## Errata for PCI 2.3

This paper lists the known errata for the PCI Local Bus Specification Revision 2.3. If you have found others, please mail them to techsupp@pcisig.com.

Figure 5-13: 32-bit Connector

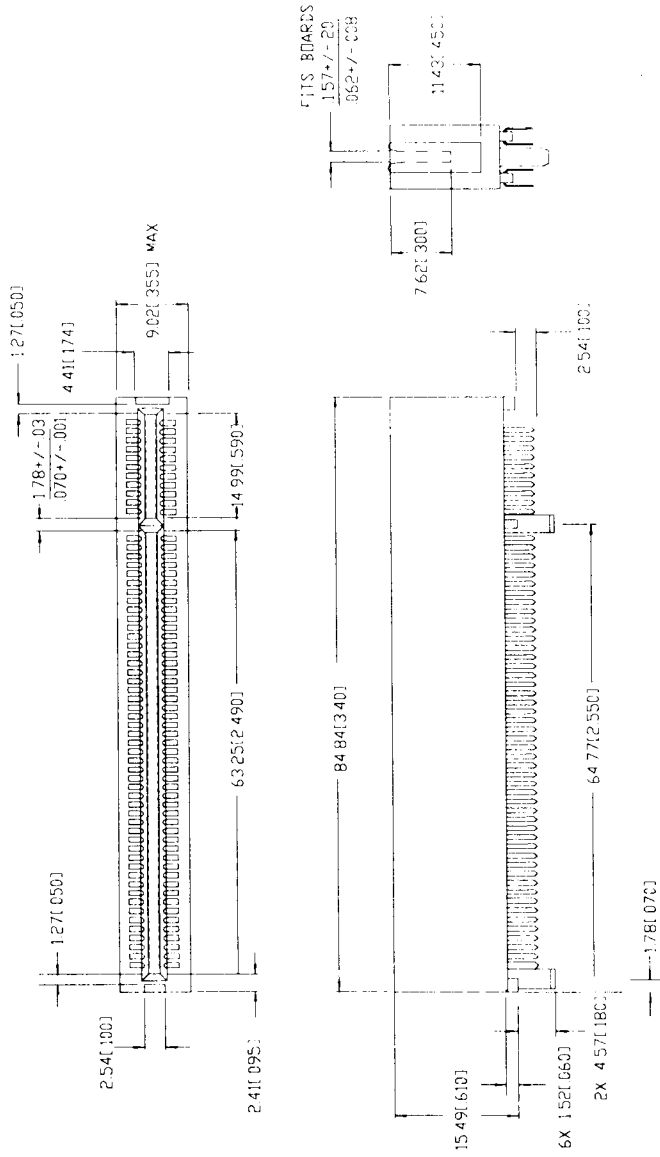
Figure 5-13 is incorrect.

- It is replaced by the following figure (this is the same as Figure 5-19 from the PCI 2.2 specification).

Figure 5-16: 5V/64-bit Connector

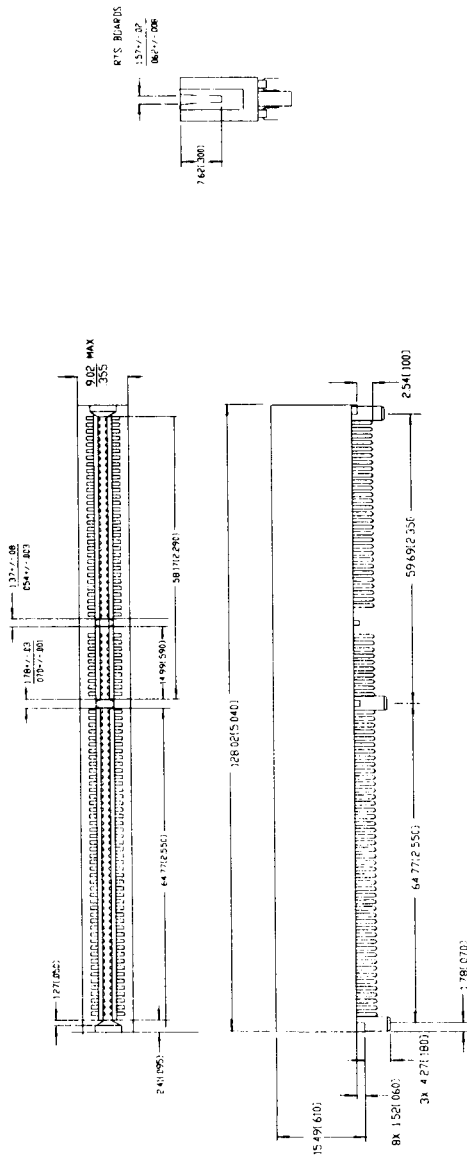
Figure 5-16 is incorrect.

- It is replaced by the following figure (this is the same as Figure 5-22 from the PCI 2.2 specification).
